Access Compliance Report Public Rights-of-Way (Curb Ramps)

Intersection ID: 10033988	Main Street: PARK_RD	Cross Street: N/A	Location: W
ADA ID: AD51C10D9FFA	Ramp Type: Directional2	Initial Pass/Fail: Fail	Overall Compliance: No Severity Score: 1.25

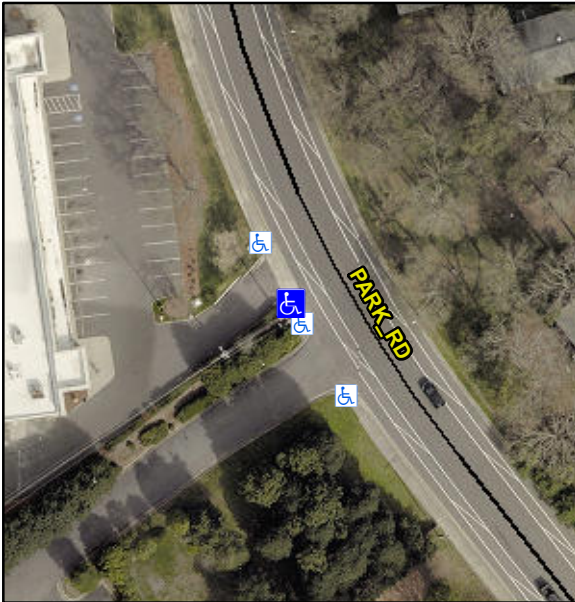
R304.5.3

Compliance	Description	Data	Compliance	Description	Data
N/A	Ramp Length (in)	54.0	N/A	Grade Break?	N/A
Yes	Ramp Width (in)	48.0	N/A	Grade Break Slope (%)	0.0
Yes	Ramp Slope (%)	6.3	N/A	Grade Break XSlope (%)	0.0
No	Ramp XSlope (%)	3.9			
N/A	Flare Type LT	N/A	N/A	Flare Type RT	N/A
N/A	Flare Slope LT (%)	N/A	N/A	Flare Slope RT (%)	0.0
N/A	Flare Traversable LT?	N/A	N/A	Flare Traversable RT?	N/A
N/A	Landing Length (in)	0.0	N/A	DWS Provided?	N/A
N/A	Landing Width (in)	0.0	N/A	DWS Contrast?	N/A
N/A	Landing Slope (%)	0.0	N/A	DWS Length (in)	N/A
N/A	Landing X Slope (%)	0.0	N/A	DWS Full Width?	N/A
N/A	Landing Curb? (Y/N)	N/A	N/A	DWS Offset LT (in)	N/A
N/A	Shared Landing?	N/A	N/A	DWS Offset RT (in)	N/A
N/A	Gutter Ponding?	0.0	N/A	Gutter Slope (%)	N/A
N/A	Gutter Lip Ht (in)	0.0	N/A	Gutter X Slope (%)	N/A
N/A	Painted X Walk1?	No		Road Slope (%)	1.3
	X Walk 1 Direction	To NW		Road X Slope (%)	3.9
	X Walk 1 Width (in)	N/A		Clear Space?	N/A

Remove & Replace Entire Ramp.
